RE: Bays West Stage 1 Master Plan Public Exhibition

Inner West Council appreciates the opportunity to comment on the exhibited draft Bays West – Stage 1 Master Plan for White Bay Power Station (and Metro) and Robert Street Sub-Precincts.

Attachment 1: Inner West Council Submission

Table 6: Parking requirement

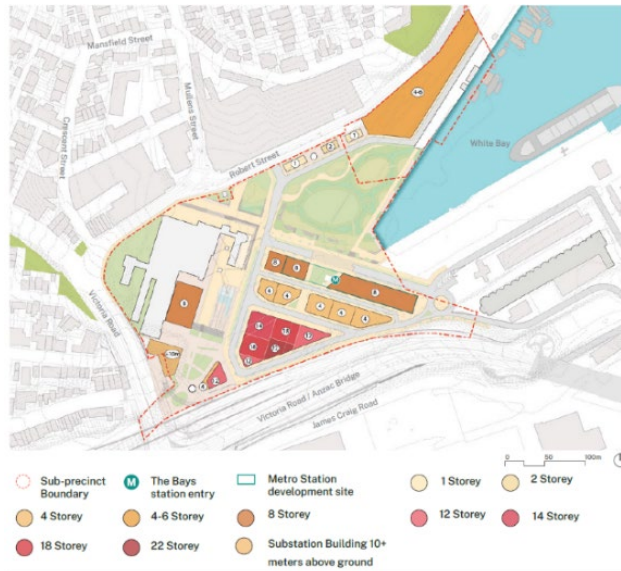
The draft Master Plan document, and Community and Council Briefings, have consistently quoted a total GFA of 130,000m² and focus on employment, with some 20,000–25,000m² for residential purposes. However, Table 6 Parking Requirements outline a significantly different land use mix (draft Transport and Traffic Impact Report, page 38) being:

Left: draft master plan building heights (page 125)

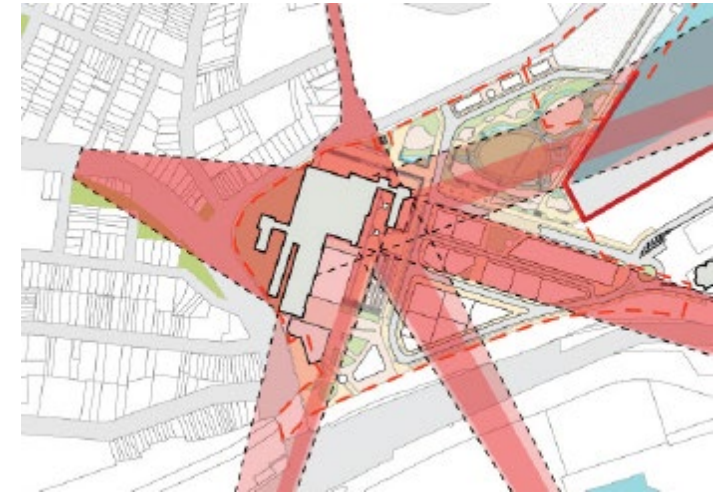
Topic	Stage 1 Master Plan proposals – summary relevant to IWC comments	Inner West Council Comments
	<p>The building heights were informed by a series of known constraints, including the significant heritage view corridors to the White Bay Power Station.</p> <p>Proposed heights are:</p> <ul style="list-style-type: none"> • 8 storeys for the metro station, services and over- station development • 4 storeys for the development immediately south of the metro station • 12 to 22 storeys for the buildings within the southern development precinct • approximately 10 metres above ground level for the substation • 1 to 2 storeys on the northern side of White Bay Park in Robert Street sub-precinct • 4 to 6 storeys for the northern component of the Robert Street sub-precinct. 	<p>Based on the high-level built form information provided, Council:</p> <ul style="list-style-type: none"> • Supports the approach taken to outline proposed building heights across the sub-precinct, specifically the 4 storeys south of the Metro station to retain views of the Power Station from Anzac Bridge. • Does not support the proposed 8 storeys for the Sydney Metro over station building. We reiterate Council comments provided on the Sydney Metro EIS Stage 3 package that – <i>building heights on the Metro Station site will impact on views to and from Anzac Bridge and to the Harbour Bridge. Further, the height of the station building as identified in Chapter 13 of the EIS is likely to exceed the maximum RL as specified in the endorsed Bays West Urban Design Framework (2021) being RL22.2. Chapter 13 of the EIS has assessed these impacts and particularly notes views of White Bay Power Station heritage item will be directly and permanently impacted. Mitigation measures largely rely on heritage design guidance however this is unlikely to overcome the proposed building height and building envelope (albeit limited information has been provided).</i> We recognise Sydney Metro is subject to a separate approval pathway and are concerned to see the draft master plan has reconfirmed building heights for the Metro site as 8 storeys, given this is inconsistent with the endorsed Urban Design Framework. • Supports the proposed active frontages and through site links, specifically through the taller building area that is a single built form block. • Supports ground floor setbacks noting further details are required on street walls, above ground setbacks, articulation etc. <p>While not outlined in the exhibited material, we are aware through DPE presentations, that the Rezoning Package will include detailed design guidelines</p>

and provide a design excellence process. We look forward to reviewing these in the next phase of consultation.
